**ADDENDUM NO. 01  
October 24, 2022**

**BALES INTERMEDIATE AND WESTWOOD ELEMENTARY RENOVATIONS ISSUE FOR  
PROPOSAL  
FOR FRIENDSWOOD I.S.D.**

Prepared by: PBK  
11 Greenway Plaza, 22<sup>nd</sup> Floor  
Houston, TX 77046-1104  
PBK Project No: 220083

1ST FLOOR POWER  
PLAN - AREA D

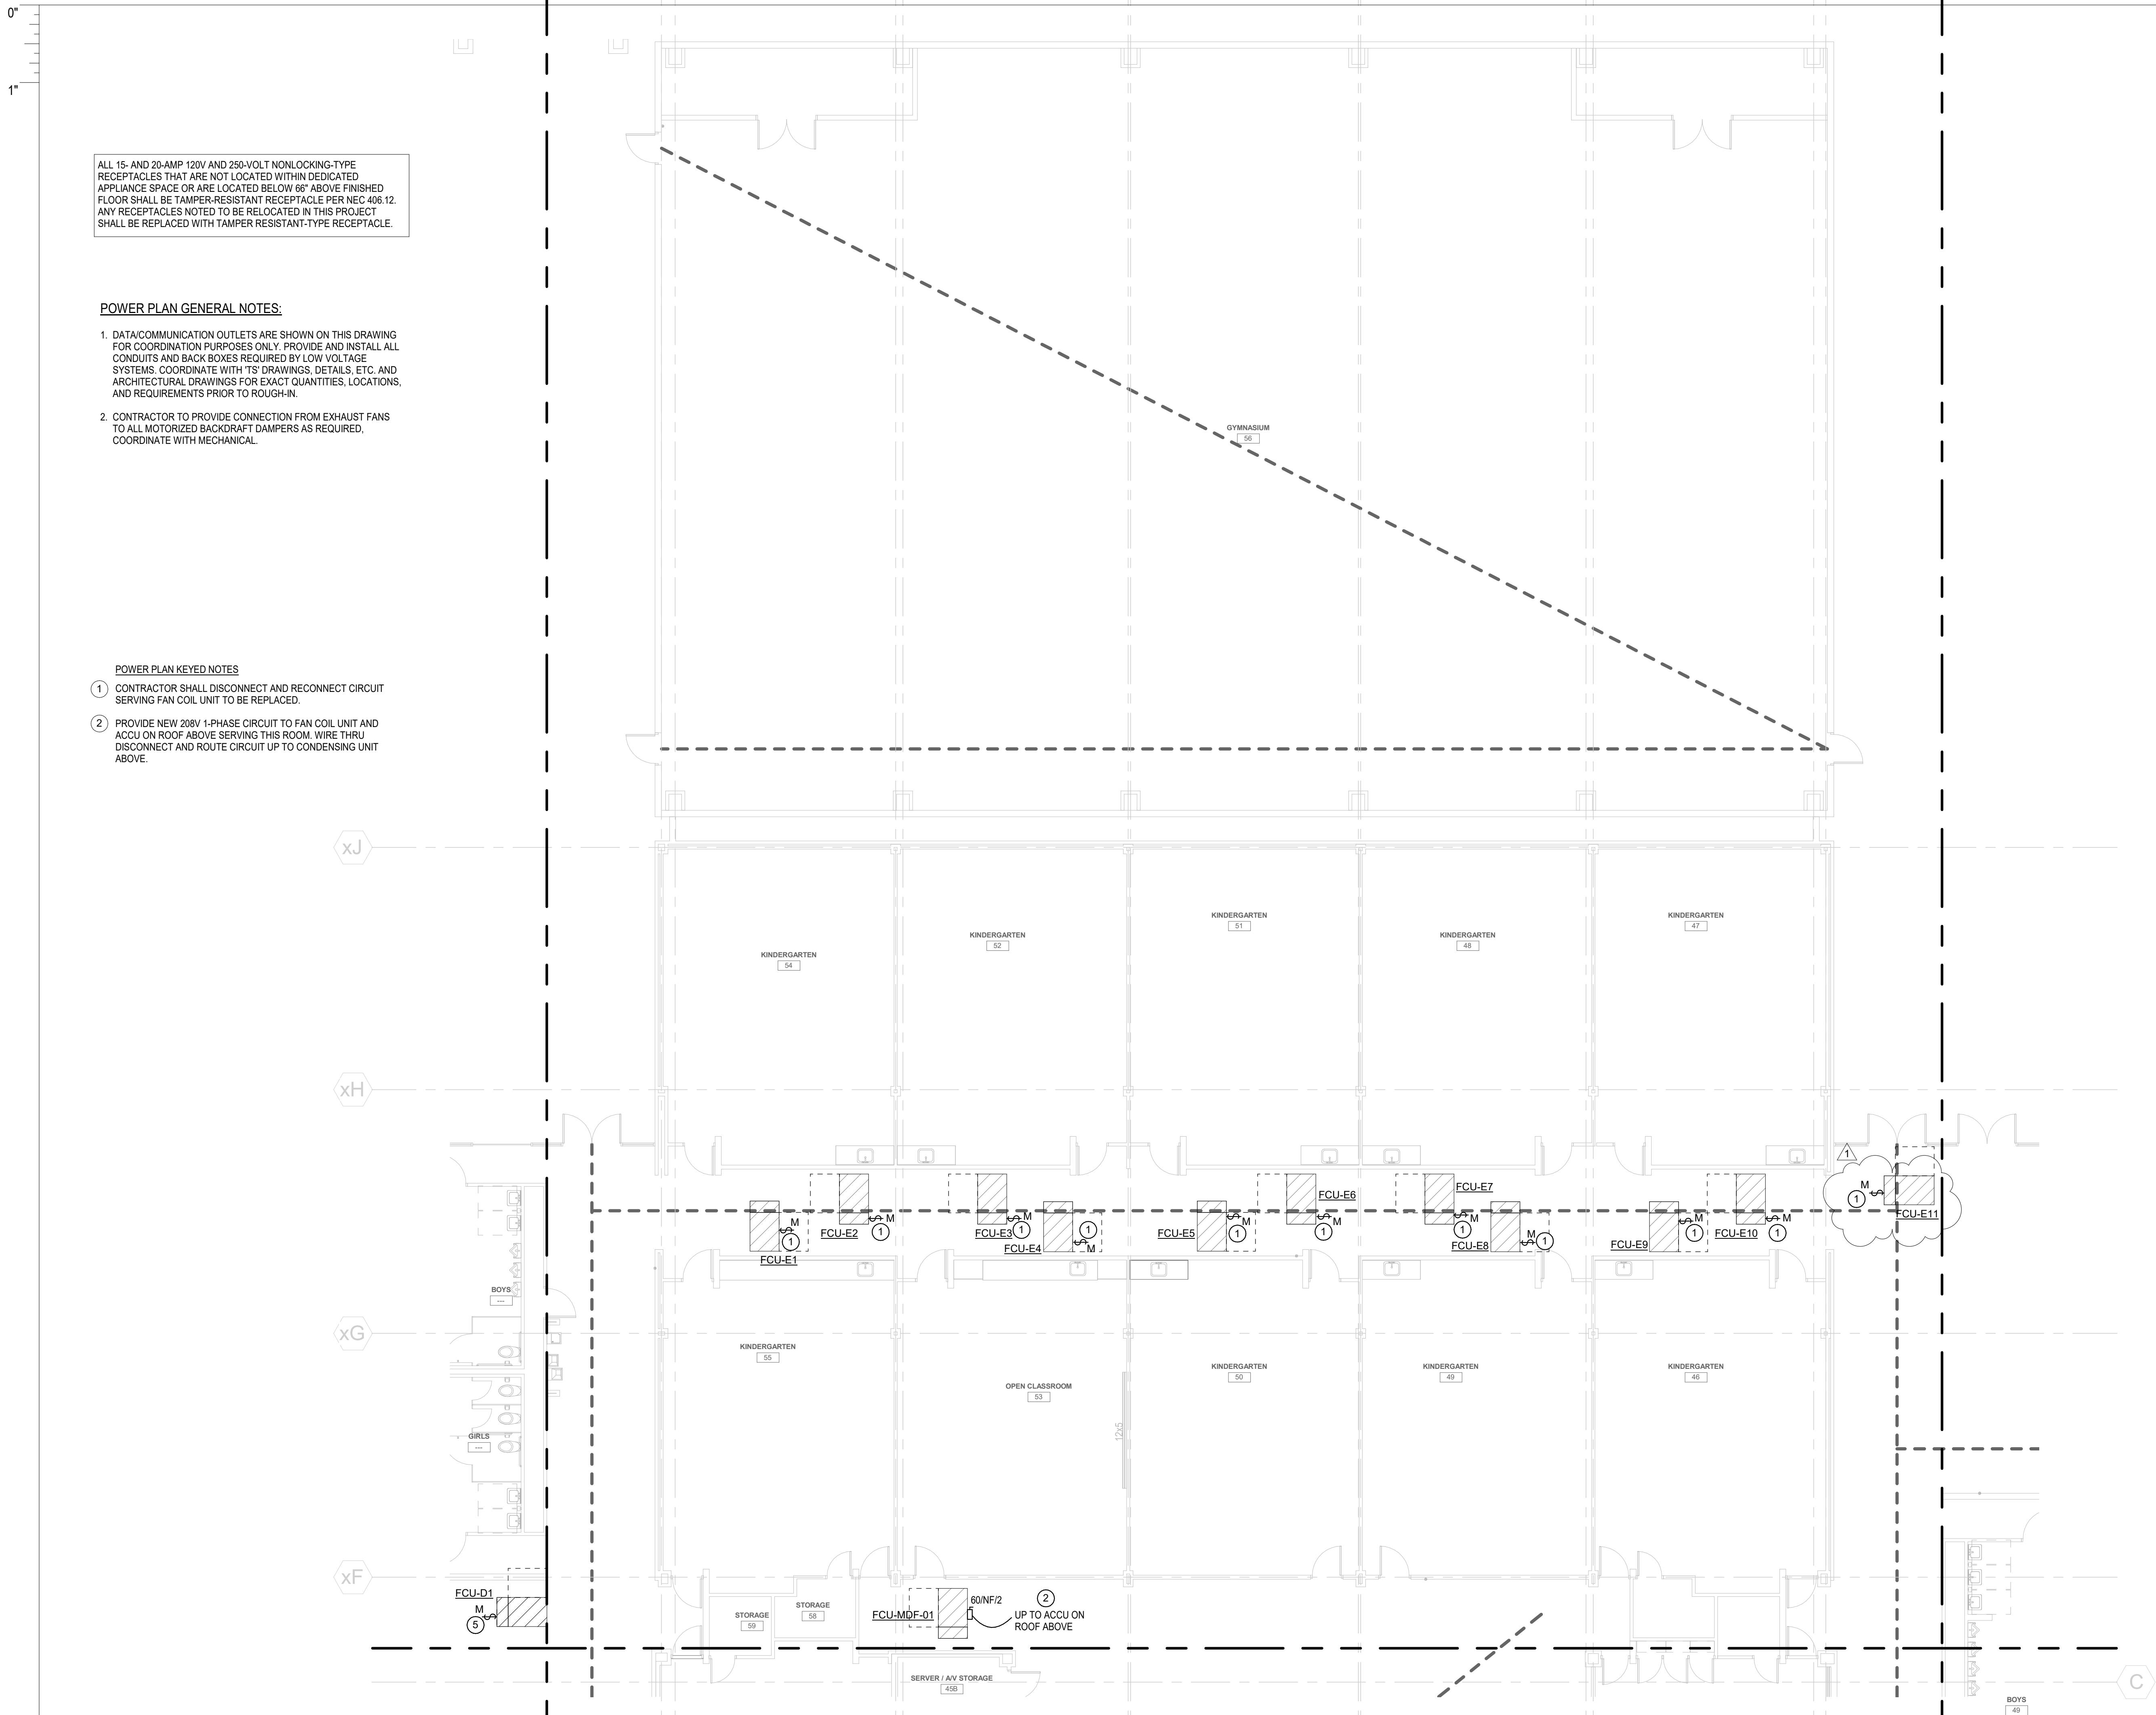
- Item No 18      **Sheet – EP-101D – 1<sup>ST</sup> FLOOR POWER PLAN – AREA D (Westwood)**
1. See attached revised sheet EP-101D for revisions to switchboard service, motor starters, and relocated transformers.

EP-102

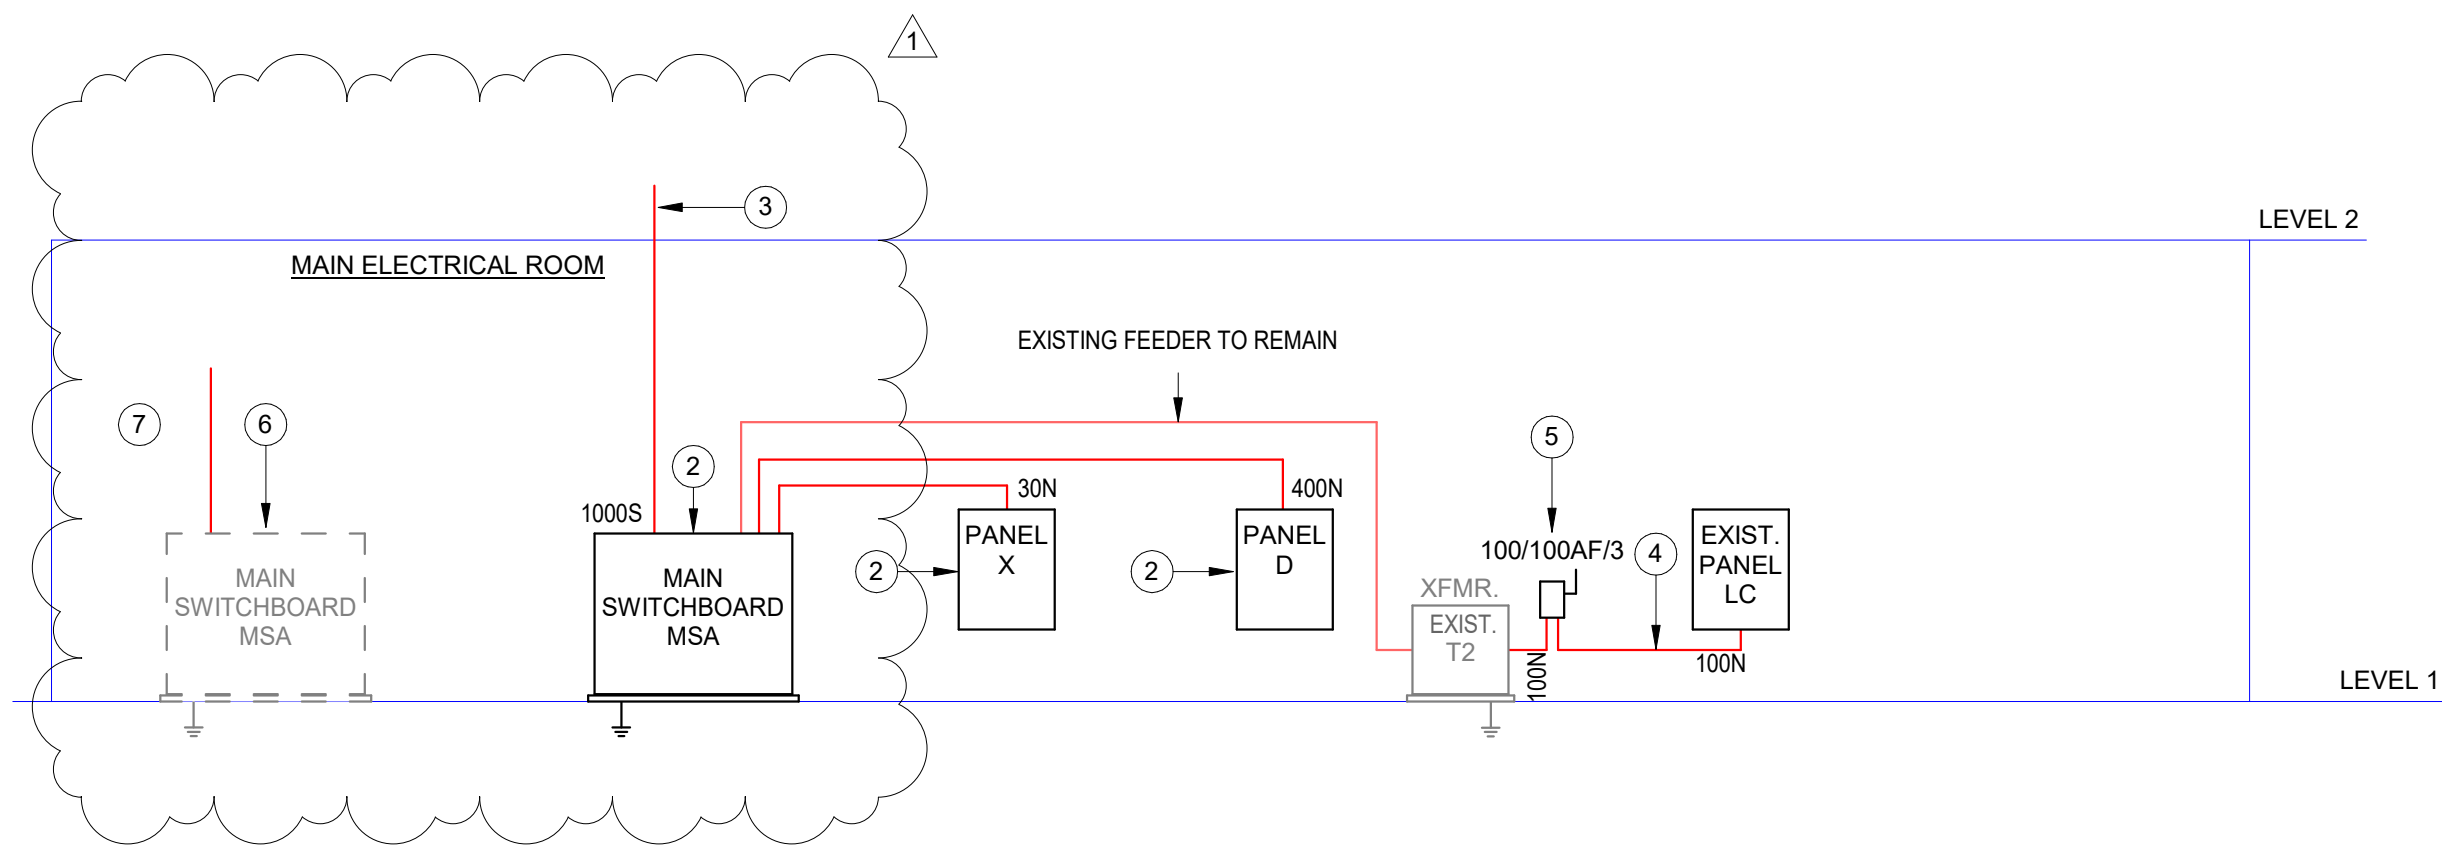
- Item No 08      **Sheet – EP-102 – ELECTRICAL ROOF PLAN (Bales)**  
1. Delete disconnect and reconnect, and motor switches to all supply fans and intakes. Total quantity (9).

2. Delete MAPA pedestal mounting for disconnect serving ACCU-C8. Revise mounting to exterior wall directly plan south of the current disconnect location.
